Reference: PA2018/0215 CR:hd

Parcel Description: Lot 10176, 10177 & 10178 - Town of Darwin 41 & 2 Stokes Hill Road & Kitchener Drive, Darwin City

Proposed Development: Subdivision and consolidation to create 7 lots

Excerpt from application, with connection indicated

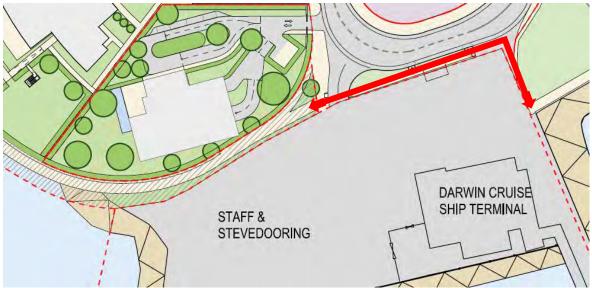
Plans submitted with the application appear to indicate that pedestrian walkways will be provided around the proposed hotel and residential developments but that there will be only a narrow connecting footpath to the existing walkway that circles around the front of the waterfront, as indicated on the below diagram.

City of Darwin requests that clear and equitable access through the site be provided for pedestrians, in accordance with the Darwin City Waterfront Planning Principles and Area Plan and the Darwin City Centre Master Plan.
